REPLACEMENT NOTE FOR REPAIR KIT WITH OVER- RUNNING ALTERNATOR PULLEY AND FLEXIBLE COUPLING SLEEVE

TECHNICAL INFO NO. 1030

Volkswagen | Multivan T5, Phaeton, Touareg, Transporter T5

2.5 TDI, 5.0 TDI

Figure 1: Over-running alternator pulley with flexible coupling sleeve and spur gear

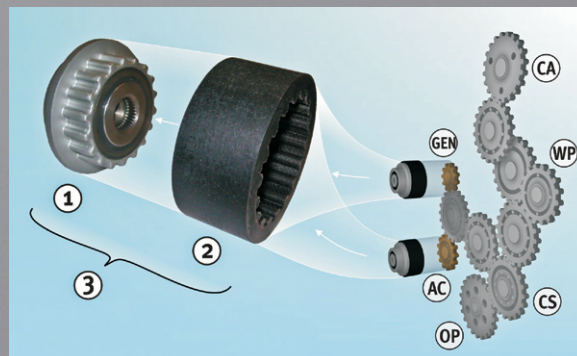
RUVILLE has implemented a part number replacement for the parts mentioned above. The replacement parts themselves have not been modified.

In this drive, the over-running alternator pulley 56328 (1) and the coupling sleeve 59947 (2) are used for both the alternator (ALT) and the air conditioning compressor (AC).

RUVILLE also offers the repair kit 59948 (3) as a complete repair solution; the kit includes the over-running alternator pulley and the coupling sleeve.
